Merged Document Report

Application No.: PL9300

| Record Type : | PLAT |

PLAT OF
 STRIPES CORPUS CHRISTI

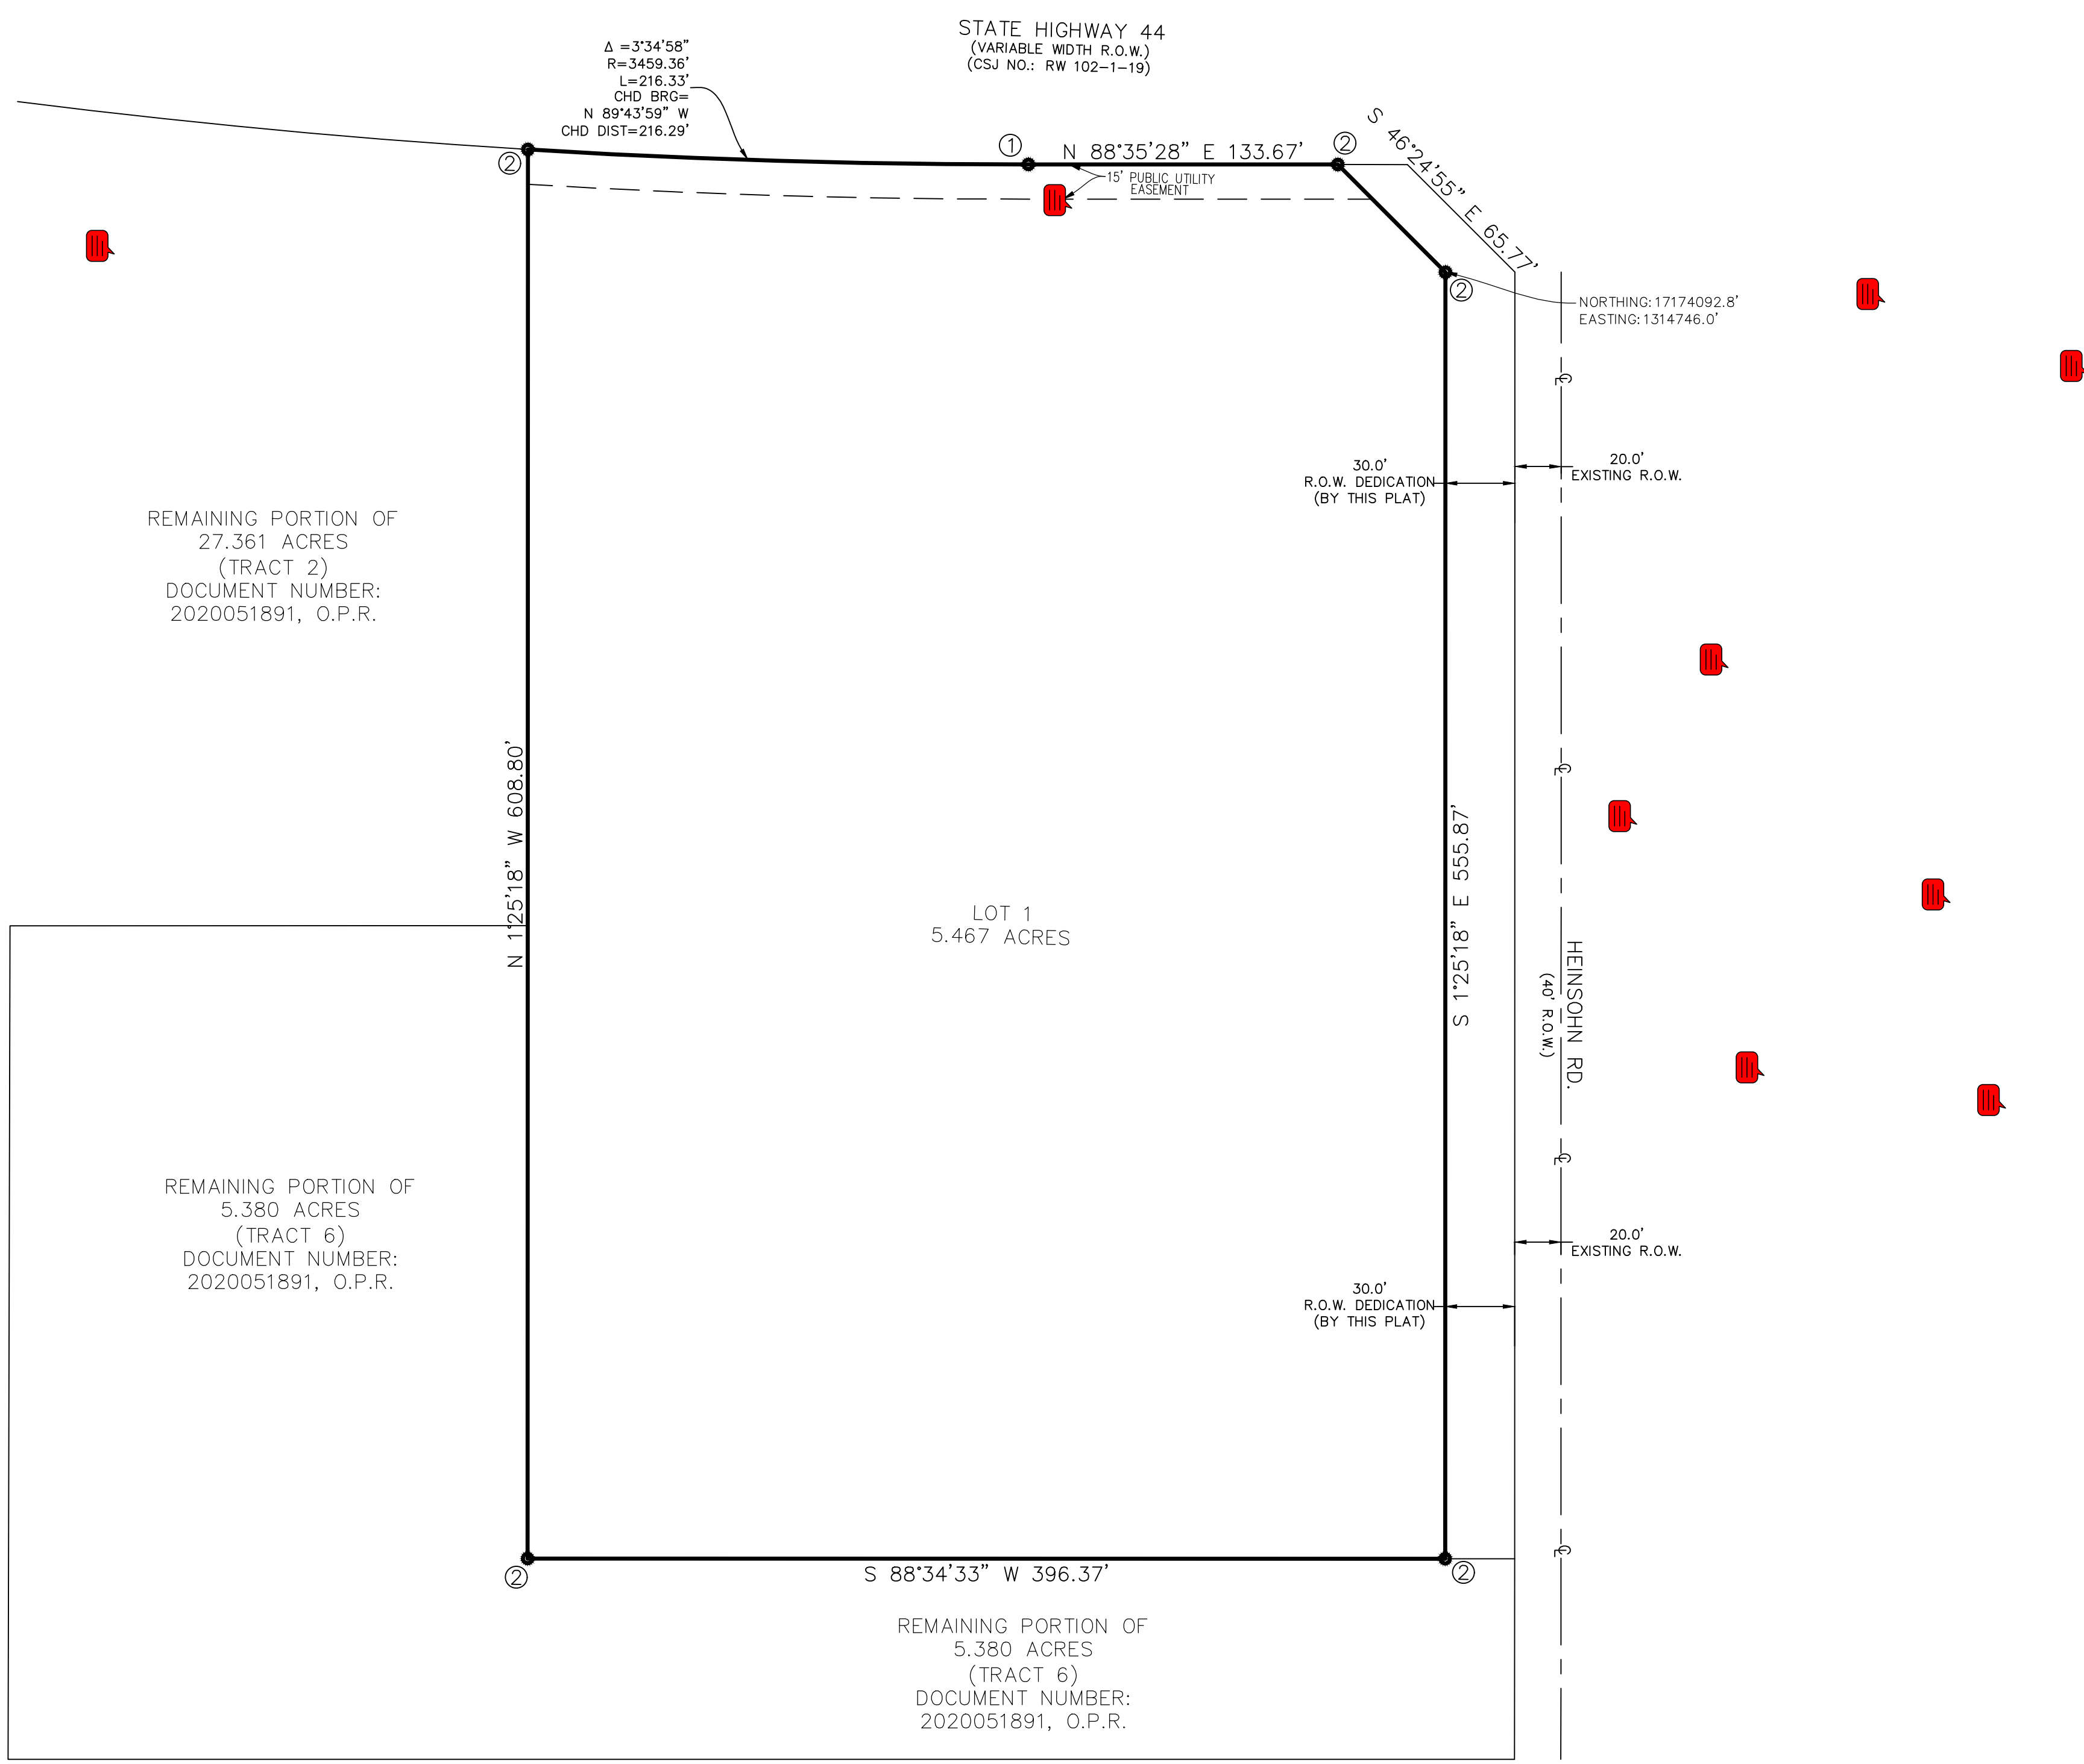
| Comment ID | Page Reference | Annotation Type | Author : Department | Status | Review Comments | Applicant Response Comments |
|------------|----------------|-----------------|---------------------|--------|--|-----------------------------|
| 3 | P001 | Note | Mina Trinidad : DS | Closed | <p>Update 6/22/26: Approved: PLAT - ROADWAY MASTER PLAN The proposed plat does not impact or alter the existing Transportation Master Plan. The plat does provide adequate ROW dedication as required per the RMP.</p> <p>Traffic/ROW: (Moises T.) PLAT - ROADWAY MASTER PLAN The Proposed plat impacts and / or alters the existing Transportation Master Plan. Plat denied - the plat must conform to the Transportation Master Plan. Option 1 Submit plat adhering to the Transportation Master Plan showing required ROW dedications Option 2 Applicant request Amendment to Transportation Master Plan Planning Commission support required Ultimate decision-making body: City Council Platting / Public Improvement process stops until amendment process is complete. Amendment process can take approximately 60 or more days depending on complexity.</p> <p>The plat did not provide adequate ROW dedication on Heinsohn Road as required per the RMP. Heinsohn Road is an A-2 (100-foot ROW) as per the RMP.</p> | |

| Comment ID | Page Reference | Annotation Type | Author : Department | Status | Review Comments | Applicant Response Comments |
|------------|----------------|-----------------|---------------------|--------|---|-----------------------------|
| 10 | P001 | Note | Mina Trinidad : DS | Closed | 06/05/26 Update: Please disregard my previous comment regarding the closure. Upon a second review of PL9300, I found that everything looks correct and it does close within acceptable engineering standards. GIS: (Ziba A.) Plat does not close within acceptable engineering standards. | |
| 13 | P001 | Note | Mina Trinidad : DS | Closed | Increase all signature block texts for better visibility when plat is recorded. | |
| 14 | P001 | Note | Mina Trinidad : DS | Closed | Replace "Michael York, Chairman" with: Cynthia Salazar-Garza Chairperson | |
| 15 | P001 | Note | Mina Trinidad : DS | Closed | Replace "Michael Diaz, Secretary" with: Michael Dice Director | |
| 16 | P001 | Note | Mina Trinidad : DS | Closed | Increase text within plat dimensions for better visibility when the plat is printed for recordation. Increase building setback line, UE line, etc. | |
